UNITED STATES PATENT AND TRADEMARK OFFICE

APPLICATION NO.	FILING DATE	FIRST NAMED INVENTOR	ATTORNEY DOCKET NO.	CONFIRMATION NO.
10/532,763	04/20/2005	Paul Gibson	HGF2	2695
6980	7590	08/25/2006	EXAMINER	
TROUTMAN SANDERS LLP 600 PEACHTREE STREET, NE ATLANTA, GA 30308			KENNEDY, JOSHUA T	
			ART UNIT	PAPER NUMBER
			3679

Office Action Summary	Application No. 10/532,763	Applicant(s) GIBSON ET AL.	
	Examiner Joshua T. Kennedy	Art Unit 3679	<i>JK</i>

Examiner's Figure 1

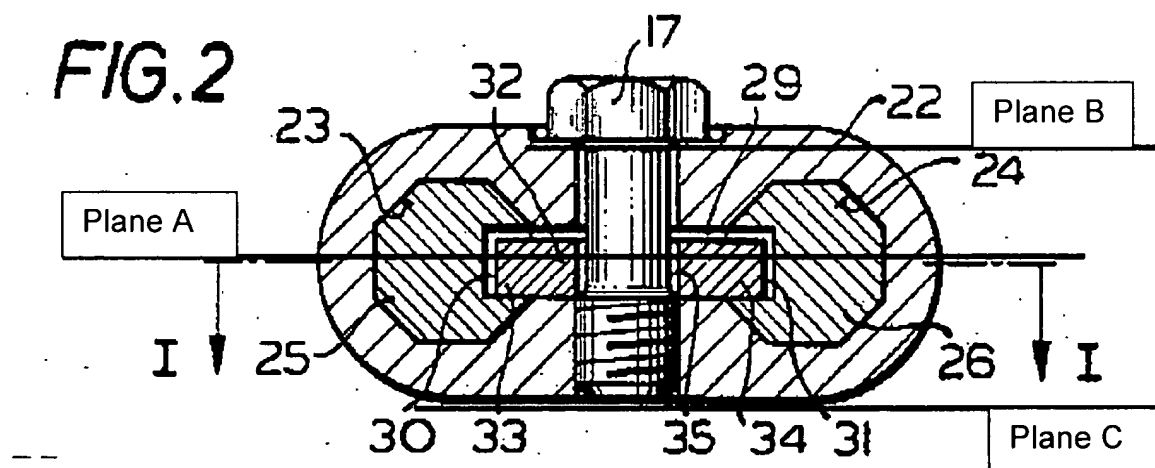
"No portion of the securing element of Ley lies outside of the body portion... The securing element of Ley contacts... only the inner surfaces of the Ley body portion/intermediate portions."

Examiner respectfully disagrees. As broadly as can be reasonably interpreted the securing element lay between an outer surface (as noted correctly on Applicants construction of Page 11 of Applicants response and in Examiner's Figure 1 below) and the head portion (17) of the securing bolt. To clarify the Examiner's position, in this particular view, the securing element lies in a plane A, the securing bolt in a plane B, and the outer surface in plane c. Plane A is located between Planes B and C; hence the securing element lay between an outer surface and the head portion.

Examiners Figure 2

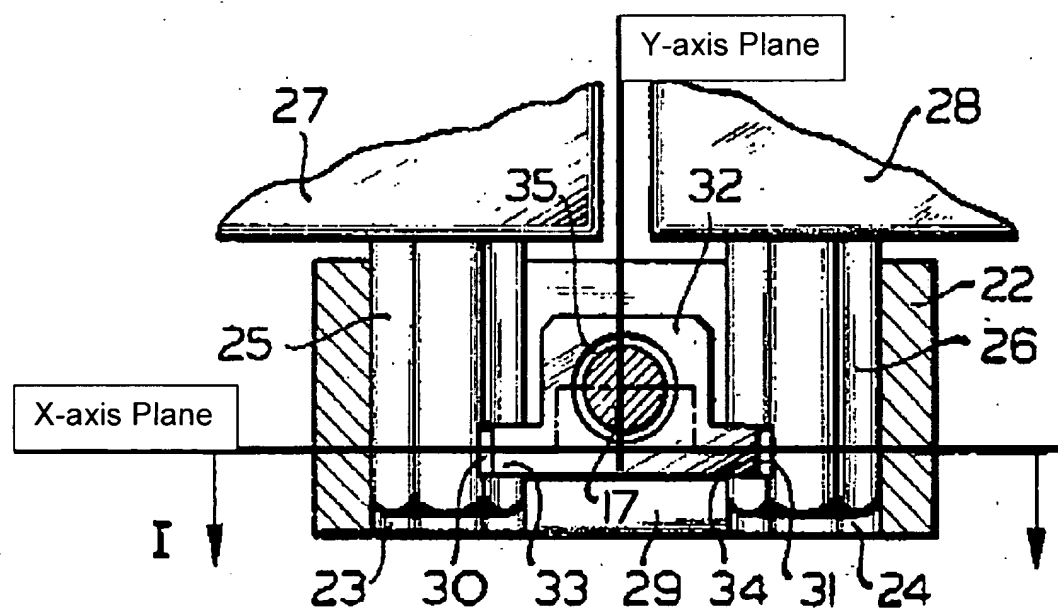
"the first and second arm portions of the securing element are in different planes...[which] is not disclosed in Ley"

Examiner respectfully disagrees. As advanced above and shown below, Examiner considers the two arm portions to lay in different planes when looking at the securing element from above (as in Figure 1); the first arm portion (32) lying in the Y-axis plane and the second arm portion (33,34) along the X-axis plane.
